SIB 64 03 22
NO HEATER OUTPUT IN PASSENGER AREA

2023-09-08

This Service Information Bulletin (Revision 1) replaces SI 64 03 22 **dated March 2022**.

CORRECTION

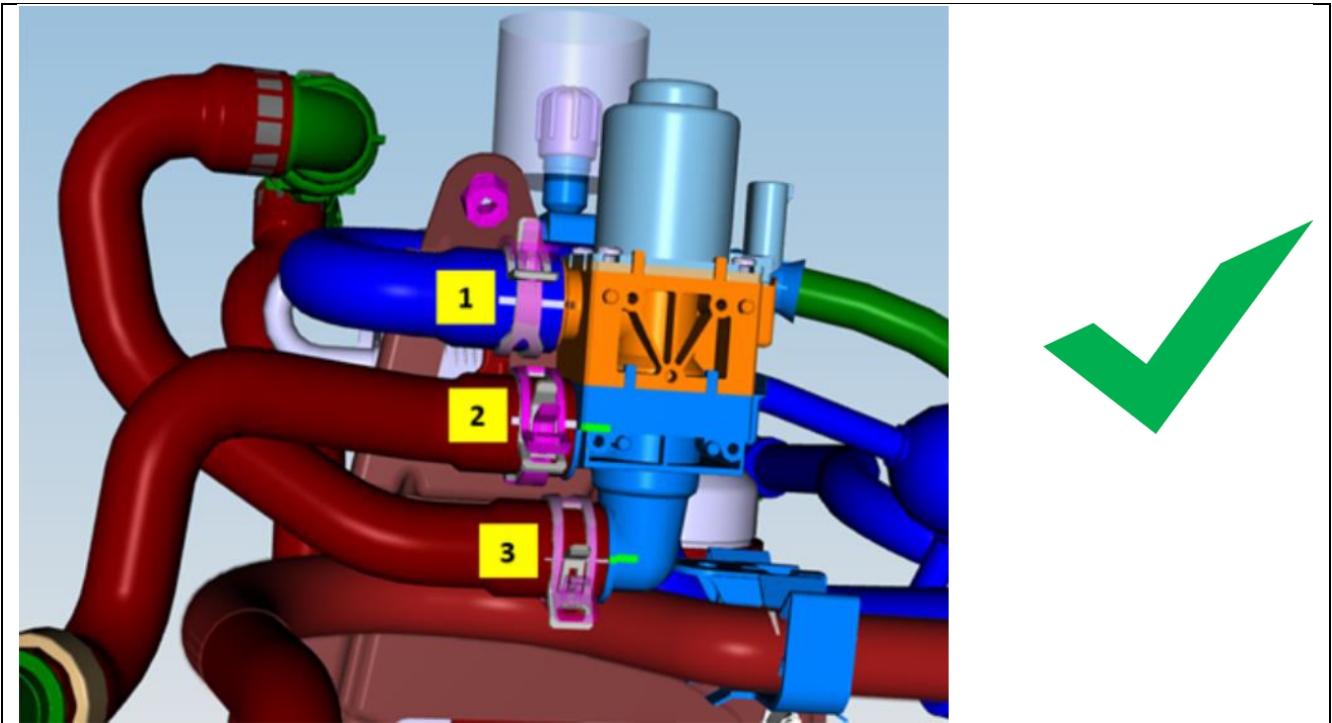
The hoses on the changeover valve are mounted in the wrong order.

Check the hose connections to the changeover valve and correct if necessary. The correct hose routing is shown below.
